Access Compliance Report

Public Rights-of-Way

(Curb Ramps)

Intersection ID: 10014099	Main Street: W W T HARRIS BV	Cross Street: N/A	Location: S
ADA ID: 48BD91261F3A	Ramp Type: ParaDiag	Initial Pass/Fail: Fail	Overall Compliance: No
Codes/Mitigation Info/Possible Solution		Field Measurements/Component Compliance	
Severity Score: 37.5

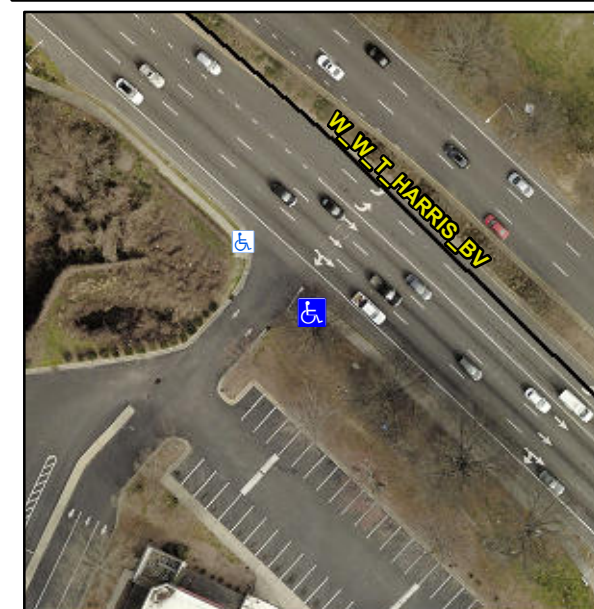
MEDIAN ACROSS W W T HARRIS BV

R304.3.2, R304.5.3

Compliance	Description	Data	Compliance	Description	Data
N/A	Ramp Length LT (in)	38.0	N/A	Ramp Length RT (in)	45.0
Yes	Ramp Width LT (in)	66.0	Yes	Ramp Width RT (in)	69.0
No	Ramp Slope LT (%)	14.4	Yes	Ramp Slope RT (%)	3.8
No	Ramp XSlope LT (%)	6.5	No	Ramp XSlope RT (%)	2.1
N/A	Landing Length (in)	N/A	N/A	DWS Provided?	N/A
N/A	Landing Width (in)	N/A	N/A	DWS Contrast?	N/A
N/A	Landing Slope (%)	N/A	N/A	DWS Length (in)	N/A
N/A	Landing X Slope (%)	N/A	N/A	DWS Full Width?	N/A
N/A	Landing Curb? (Y/N)	N/A	N/A	DWS Offset (in)	N/A
N/A	Shared Landing?	N/A			
N/A	Gutter Ponding?	N/A	N/A	Gutter Slope (%)	N/A
N/A	Gutter Lip Ht (in)	N/A	N/A	Gutter X Slope (%)	N/A
N/A	Painted X Walk1?	No	N/A	Painted X Walk2?	No
	X Walk 1 Direction	To NE		X Walk 2 Direction	To NW
N/A	X Walk 1 Width (in)	N/A	N/A	X Walk 2 Width (in)	N/A
	X Walk 1 Slope (%)	4.7		X Walk 2 Slope (%)	0.8
	X Walk 1 X Slope (%)	1.9		X Walk 2 X Slope (%)	6.2
N/A	Ramp inside XWalk1?	N/A	N/A	Ramp inside XWalk2?	N/A

Remove & Replace Curb Ramp With Two New Directional Ramps or Equivalent.
